Determination 2011/029

Dispute over the slope of an existing deck to a house at 7A Churchill Road, Murrays Bay, North Shore

Figure 1: First floor plan as submitted for consent (deck shown shaded)

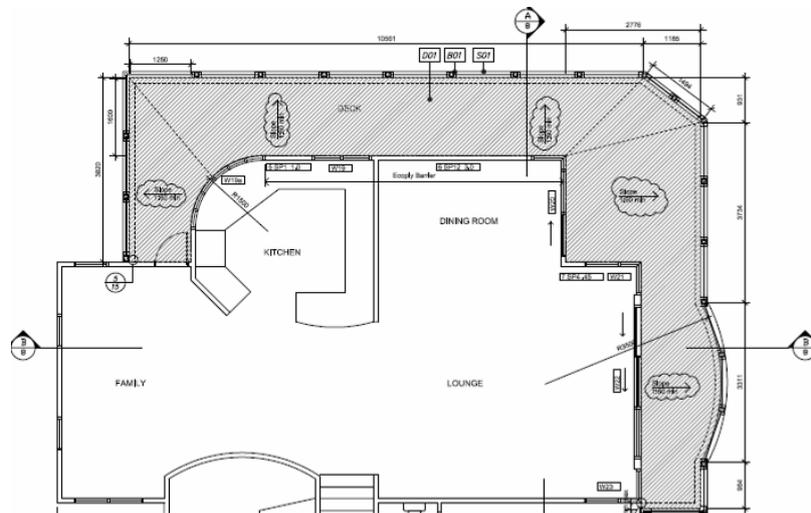
- 2.2.1 The upper level deck wraps around the north east and south east elevations, with the deck floor situated above lower rooms. The drawings show a minimum fall of 1:60. The existing deck is to be stripped back to the original floor joists with any decayed timber framing to be replaced.

- 2.2.2 New work includes new H3.2 boundary joists which oversail lower walls by about 50mm; with a new 19mm H3.2 treated plywood deck floor substrate extending a further 65mm. An aluminium angle is fixed to the underside of the plywood and the deck membrane turns down and is fixed to the leg of the angle to form a drip edge. The layout of the deck is shown in Figure 1.

3.2 When the applicant uplifted the approved consent drawings, the architect found that the plans had been annotated by the authority. The specified falls had been crossed out and replaced with ‘1:30 min’ in line with the authority’s requirements for this particular membrane (see paragraph 5.1.2). The framing plan for the deck was annotated with the hand written note ‘Nogging⁵ at 400mm min. centres to support plywood, refer to membrane manufacturers specifications’.

- 5.2.1 I note that the width of the deck generally varies from about 1.2m to 1.6m, except at the north corner where the walls are recessed and the width increases to about 2.8m. The manufacturer's installation instructions do not appear to require solid blocking at 400mm centres as sought by the annotation added by the authority. I accept that solid blocking will be required to support the plywood sheet edges. Solid blocking at 400mm centres also exceeds the requirements of NZS 3604.

5.3.1 I note discrepancies in the drawings between the description of the deck framing taken from the authority's records and as shown in the details for the proposed work, in respect of joist sizes and how the deck falls are to be achieved. I suggest that as-built drawings are provided once the existing framing is exposed and new work completed.

5.2.5 Taking into account the above observations, I am satisfied that the replacement deck floor proposed for this house is likely to perform at least as well as the materials and systems included within E2/AS1.

5.2.6 I therefore have reasonable grounds to conclude that the proposed deck floor system, including the deck fall specified in the consent application, will meet the performance requirements of Clause E2 for the deck to shed water.

6.1 In accordance with section 188 of the Building Act 2004, I hereby determine that the decision of the authority to issue the building consent, subject to amendments that it made, was incorrect. The decision of the authority to issue the building consent is modified to remove the amendments made by the authority.
